Date: March 11, 2003

To: T10 Committee (SCSI)

From: George Penokie (IBM/Tivoli)

Subject: Section 7 SL Changes

Figure 67 — SL_IR (link layer identification and hard reset) state machines

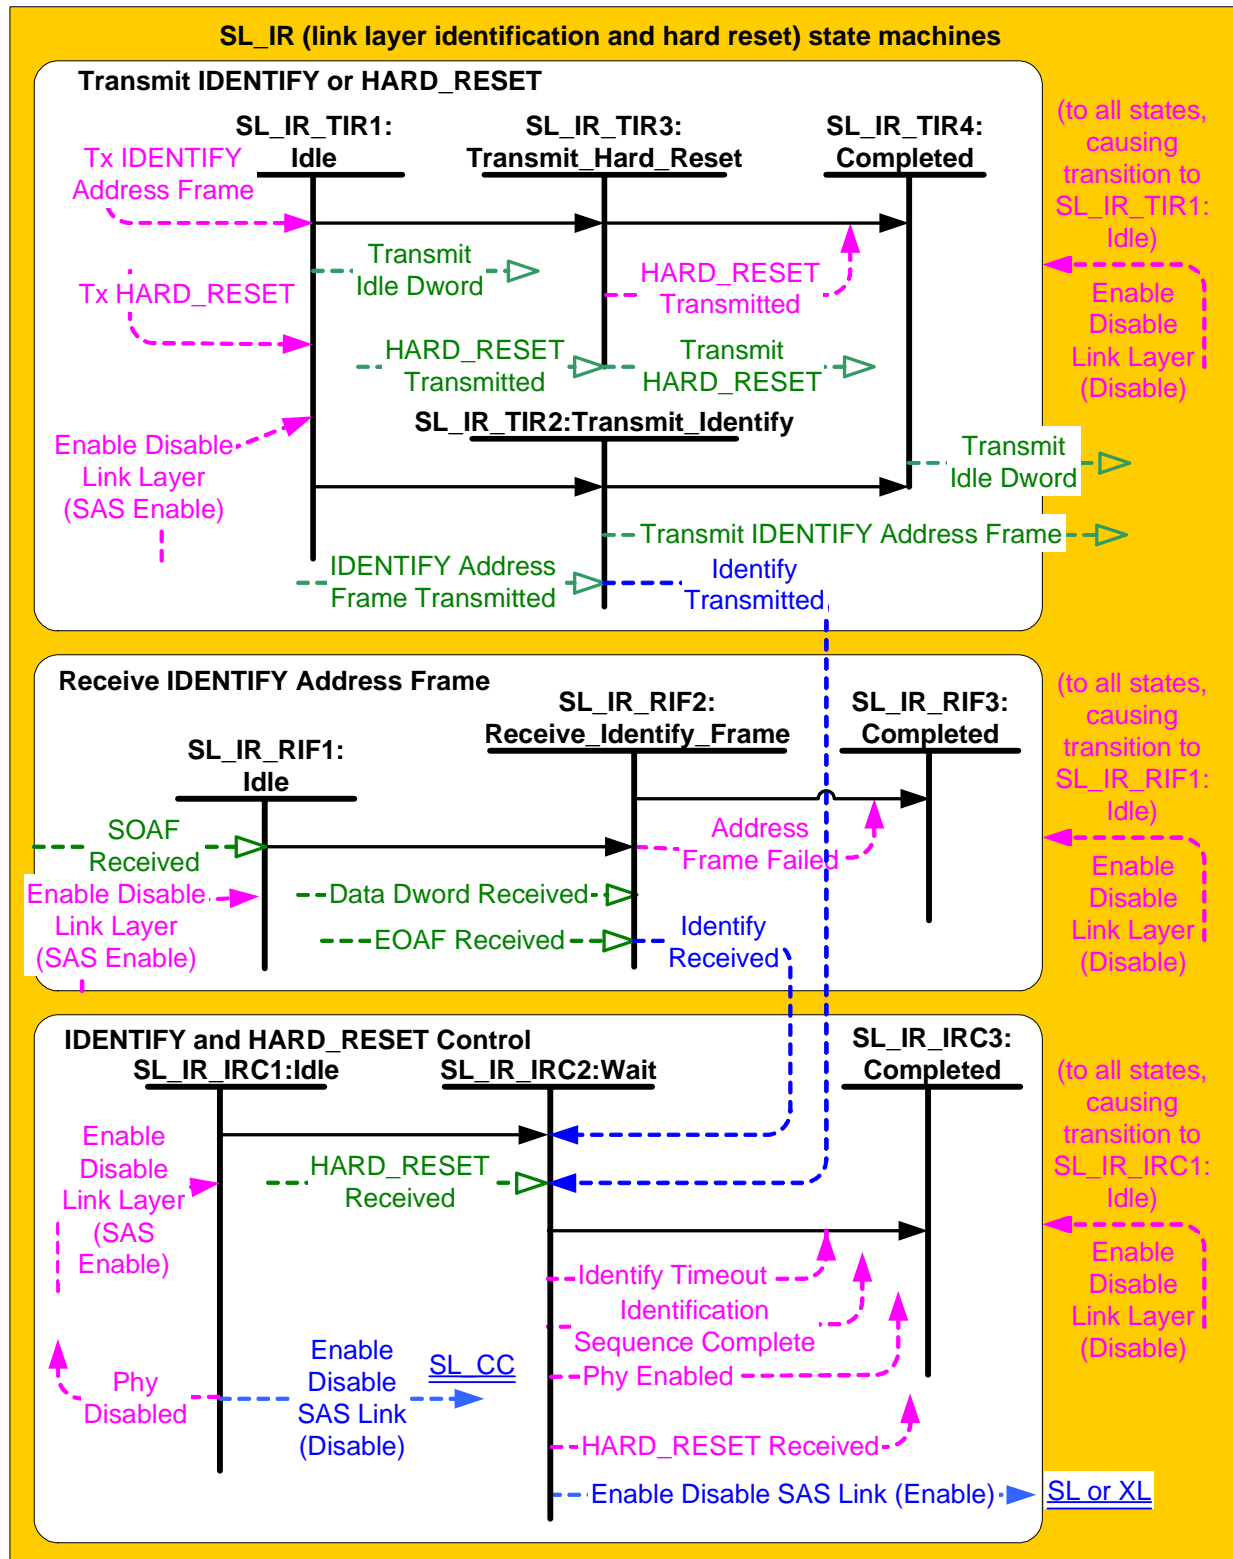
The SL_IR state machines send the following messages to the link layer state machine - ~~SL~~SL CC (see 6.15) in SAS devices or XL (see 6.16) in expander devices:

Figure 89 — SMP_IP (link layer for SMP initiator phys) state machine

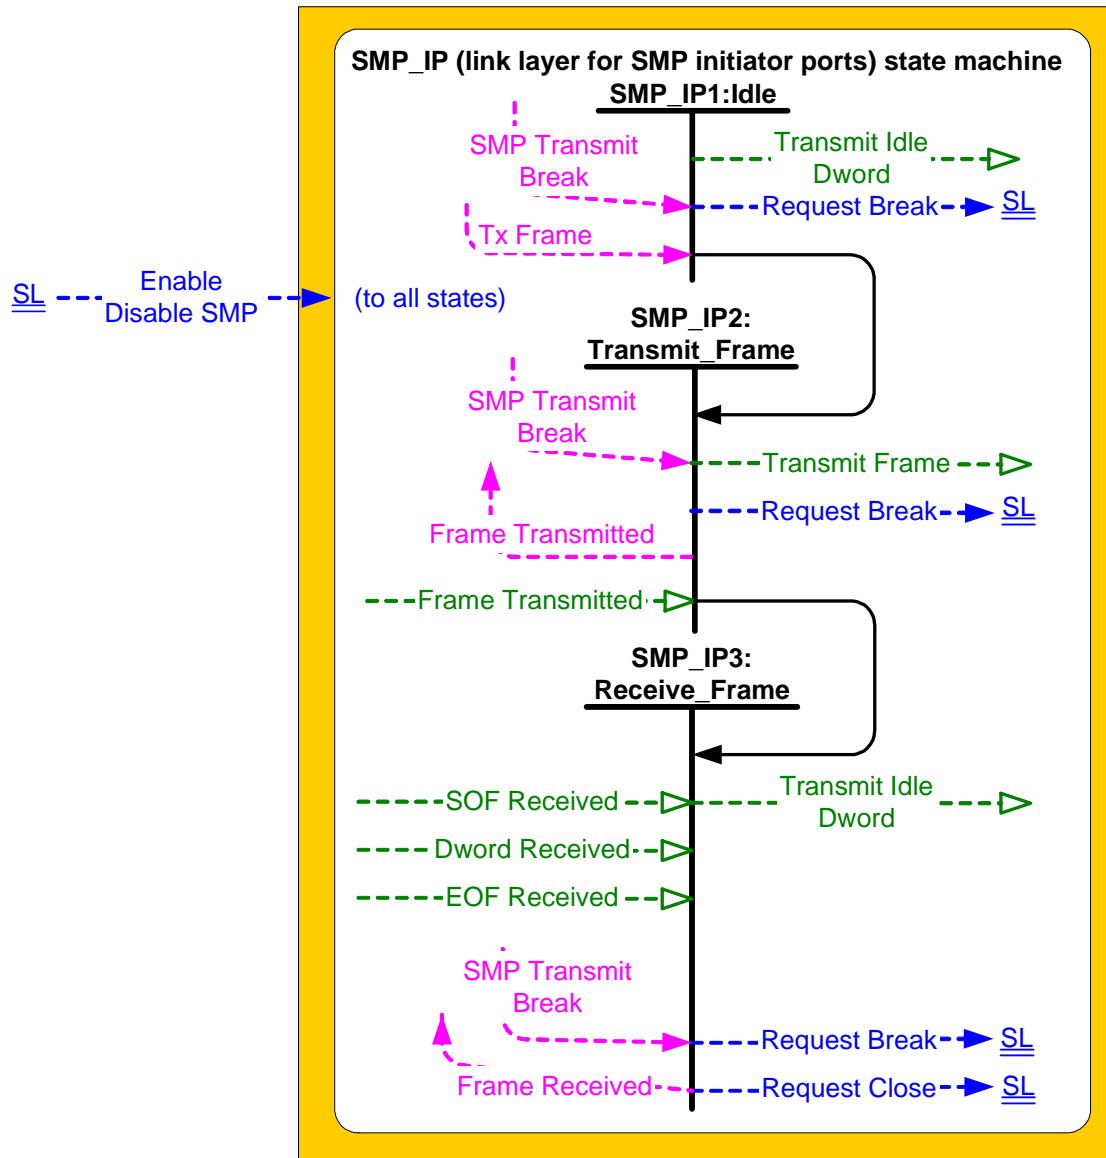
The SMP_IP state machine shall terminate after receiving an Enable Disable SMP (Disable) message from the ~~SL~~SL CC state machine.

Figure 90 — SMP_TP (link layer for SMP target phys) state machine

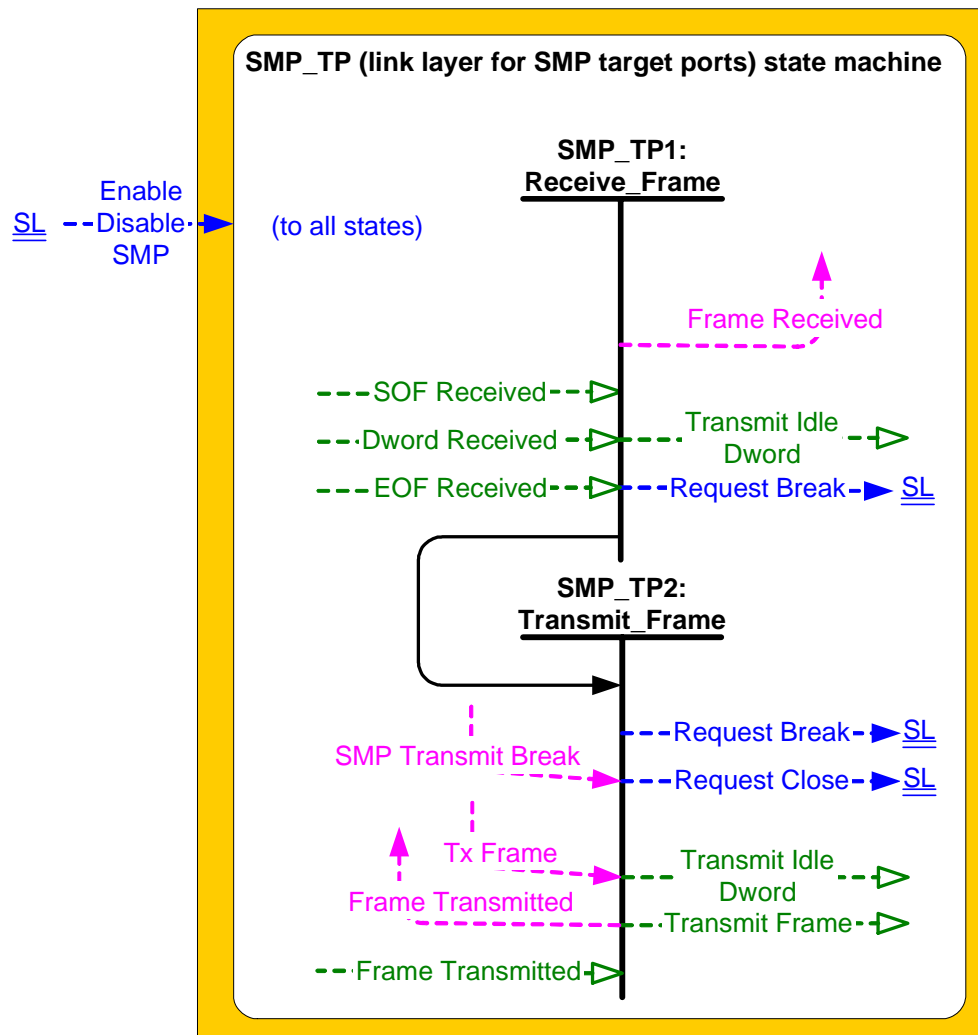
The SMP_TP state machine shall terminate after receiving an Enable Disable SMP (Disable) message from the ~~SL~~SL CC state machine.
